ENVIRONMENTAL REVIEW TEAM REPORT

Lakewood Subdivision & Landmark Estates Subdivision Bridgewater, Connecticut

Bridgewater Conservation and Inland Wetlands Commission

OCTOBER 1986

**LAKWOOD SUBDIVISION
CONCEPTUAL SITE PLAN**

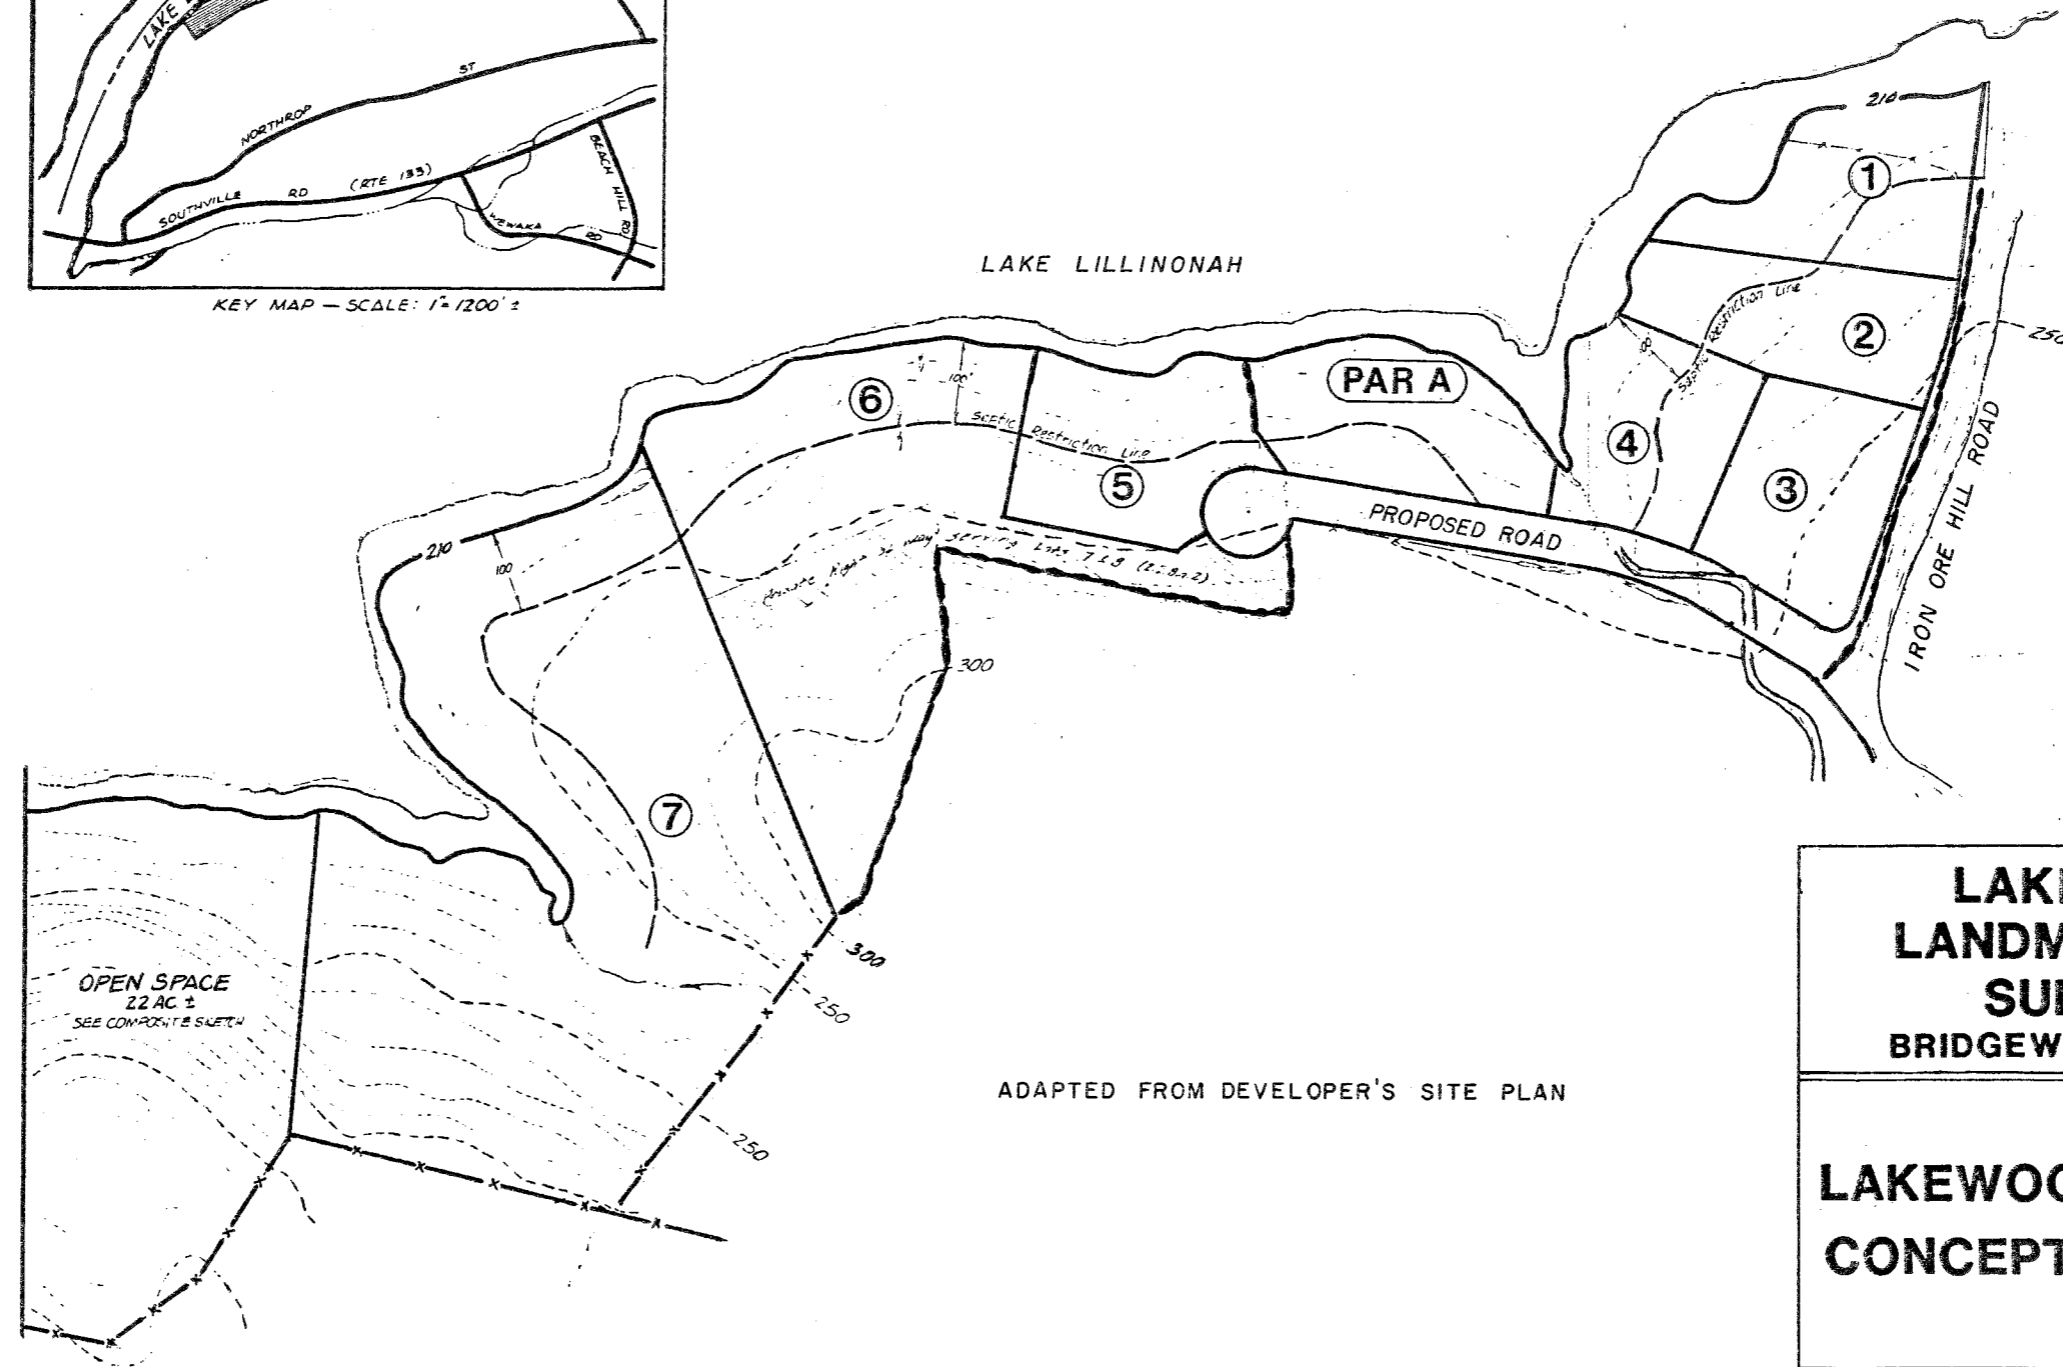
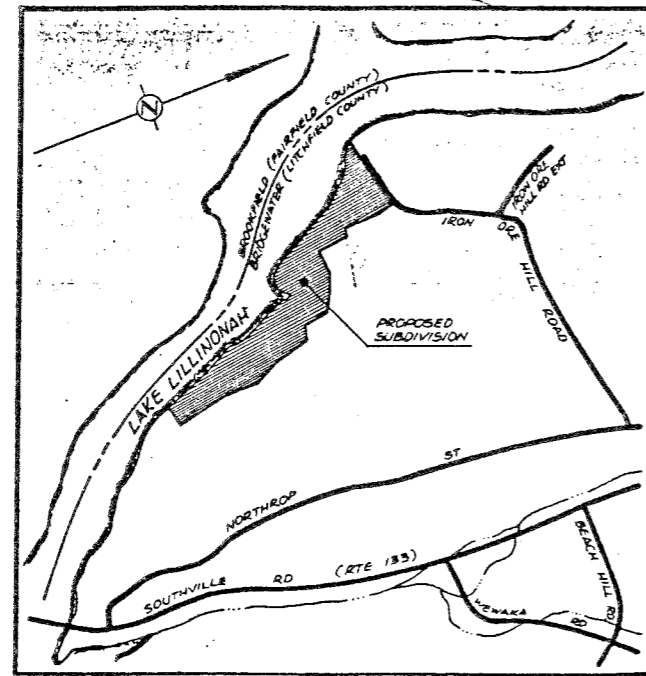
Based on the plans submitted to Team members on the review day, at least one major wetland crossing is proposed in the western portions of the site. It appears that the proposed cul-de-sac would be constructed over about 220 feet of a streamcourse/ravine system. Based on visual observations made during the field review, it appears that a considerably lesser wetland disturbance could be accomplished if the road was shifted either north or south of the proposed road crossing. The applicant's engineer and soil scientist should consider realigning the road so that there is minimal wetland disturbance.

The potential for shallow to bedrock soils combined with the presence of moderate to very steep slopes on Lots 6 and 7 in the central parts may require detailed plans prepared by a registered professional engineer. Since septic systems are not permitted to be constructed within 100 feet of Lake Lillinonah's high water mark, contamination of water quality from possible untreated domestic wastes should be minimized.

Besides flooding problems, increased runoff can lead to additional water-related problems such as streambank erosion and gullying. In view of the moderate slopes present in the area of Lots 1-5 and steeper slopes Lots 6 and 7, every effort should be provided to prevent potential erosion and siltation problems, particularly from reaching Lake Lillinonah. In this regard, it is encouraged that a comprehensive erosion and sediment control plan be developed covering each stage of the proposed subdivision. Disturbed areas should be kept to a minimum under such a plan. The erosion and sediment control measures called for under the plan should be shown on the subdivision plan.

Another concern is the proposed new road crossing of the unnamed stream/drainage channel traversing Lots 3 and 4 in the Lakewood Subdivision. To avoid disruption of a sizable length of this stream channel, consideration should be given to relocating the northern portion of this road to the west between Lots 2 and 3.

**LANDMARK ESTATES
SUBDIVISION
CONCEPTUAL SITE PLAN**

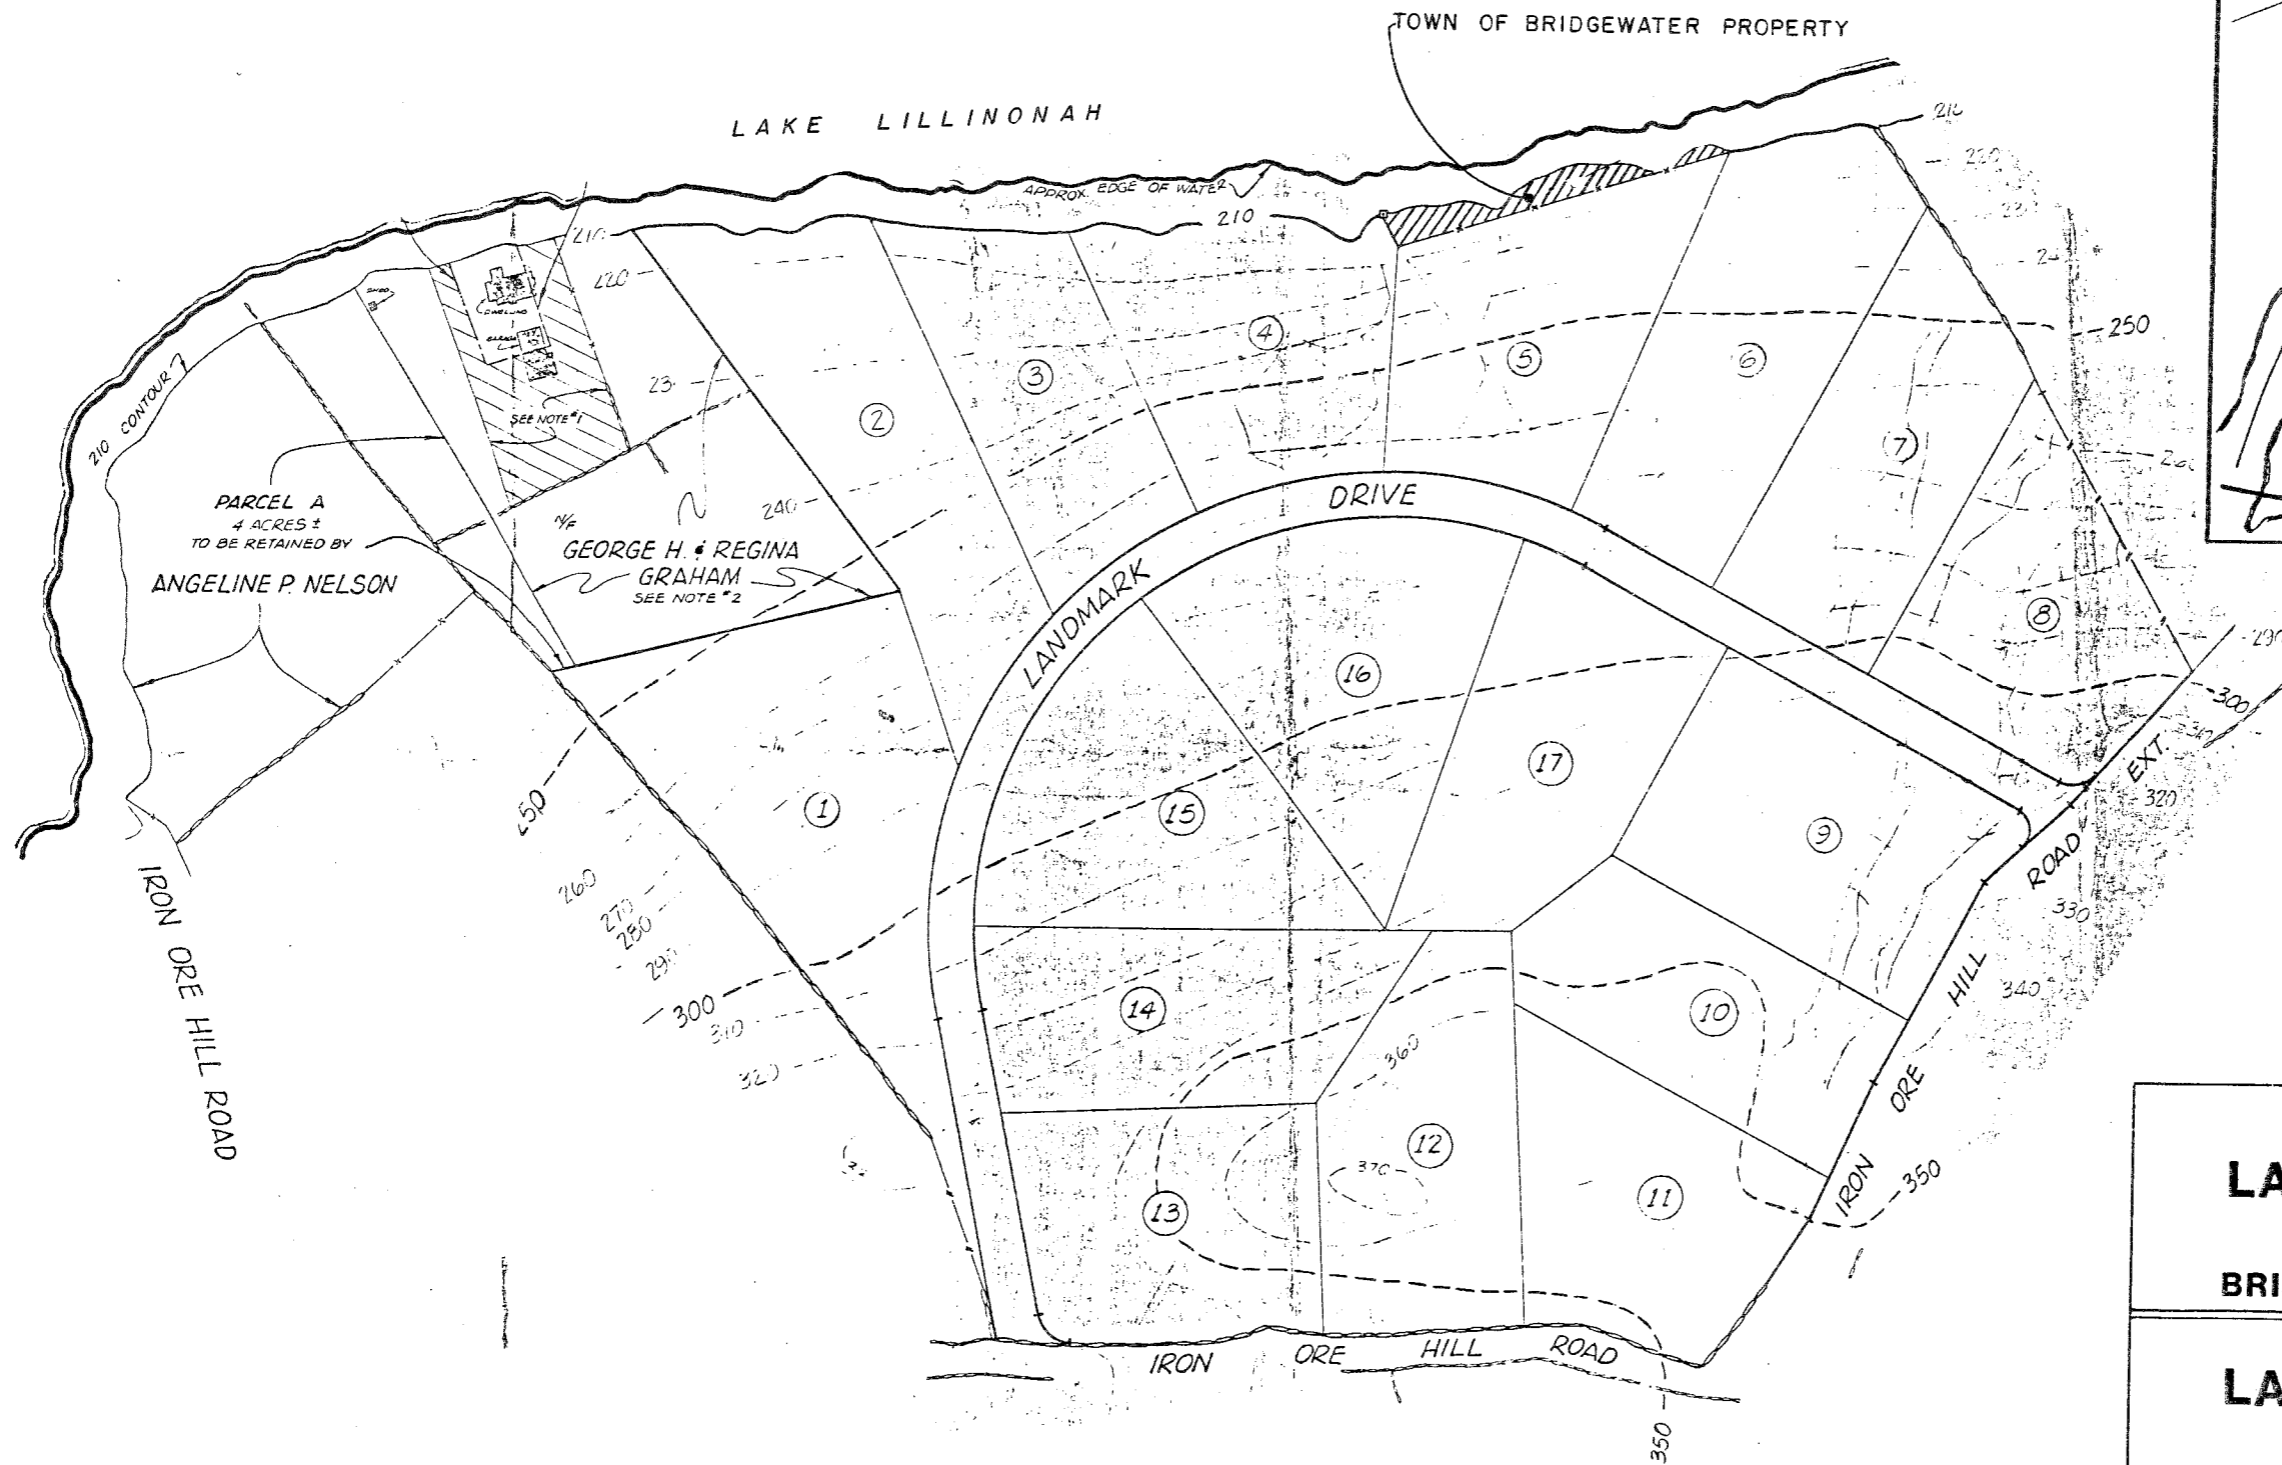
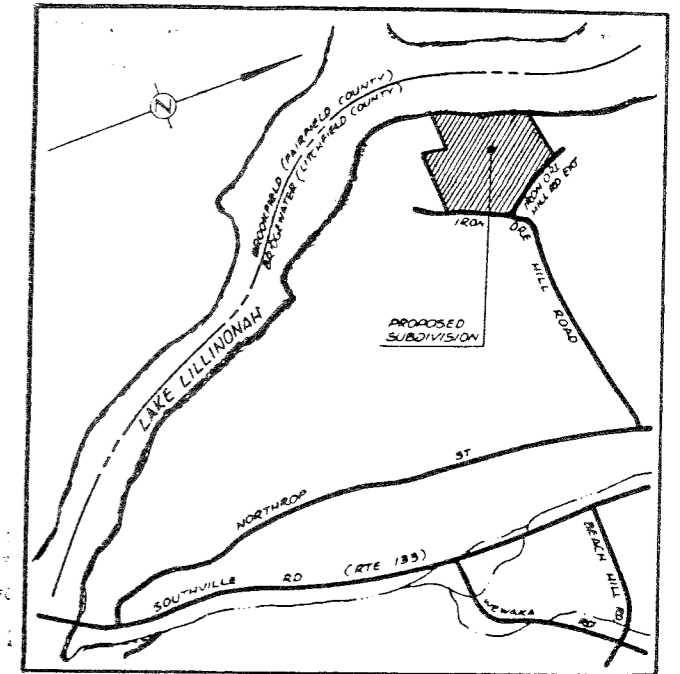
According to the proposed Landmark Estates site plan, Lots 4, 5 and 7 contain inland wetland soils. In fact, the proposed primary and reserve leaching systems on Lot 7 is bisected by regulated inland wetland soils. Also, potential dwelling sites and leaching systems located for Lots 4 and 5 are not depicted on the site probably because of limited non-wetland soils. Pending the outcome of detailed soil testing on these lots, there appears a chance that these lots may need to be combined with adjoining lots in order to properly locate a septic system, house, and well, in compliance with all necessary Public Health Code regulations.

It is understood that a 100-foot setback for building and septic systems is required from the high water mark of Lake Lillinonah. This setback boundary was not indicated on the subdivision plan distributed to Team members. It is suggested that it be superimposed so as to ensure compliance of the setback requirement.

Based on the proposed site plan submitted to Team members on the review day, a total of about 125 feet of inland wetland soils will need to be crossed in order to construct the proposed Landmark Drive. Although undesirable, wetland road crossings are feasible provided they are properly engineered. The road should be constructed adequately above the surface elevation of the wetlands. This will allow for better drainage of the road and also decrease the frost heaving potential of the road. Road construction through wetlands should preferably be done during the dry time of the year and should include provisions for effective erosion and sediment control. Finally, culvert(s) should be properly sized and located so as not to alter the water levels in the wetland or cause flooding problems. Also, there is a chance the driveways may need to cross

The proposed site development plan does not show the 100-foot septic system setback from Lake Lillinonah. Ten-foot contour intervals are not detailed enough for planning. Many drainageways were observed during the field review and they do not show on a map of this scale. That information is very important when reviewing land disturbances. Several culvert crossings are necessary and are not located on the plans. Pipe crossings need to be sized and properly installed to eliminate future drainage problems. Several dwellings as well as septic systems are shown being built in existing drainageways on somewhat poorly drained soils. No information is shown on how this water will be handled. Many serious problems can arise if the drainageways are not properly handled. Fill alone will not be sufficient. Deep test pits should be dug at the location of

each septic system because of soil limitations. Due to the extent of wetlands on Lots 4 and 5, they may need to be combined into one lot or eliminated. Again because of the lack of detailed topographic information there may be other drainageways that could cause problems on Lots 7 and 8. Storm drains for the roadway do not show any detail for inlet or outlet protection. Storm drain calculations should also be included for review. Stormwater runoff would have a minimal effect on the lake.

The proposed subdivision site plan for Landmark Estates, dated 1/8/86, shows proposed building site locations for each of the proposed lots. In preparing the final site plan for this project, efforts should be taken to re-orient many of these proposed building locations to take advantage of solar access. In particular, Lots 11, 12, 13, 14, and 15 are characterized by southerly and southwesterly slopes and have good potential for the provision of solar-oriented houses. To accomplish this, the proposed houses would simply need to be re-oriented on the proposed lots so that the long axis of the house faces south. Research has shown that energy savings in the Northeast can be significant (e.g., 12 - 14 percent) simply by orienting houses to face south. Although future homeowners can generally orient their house on the lot as they wish, suggesting a solar orientation on the site plan encourages this energy efficient development pattern.
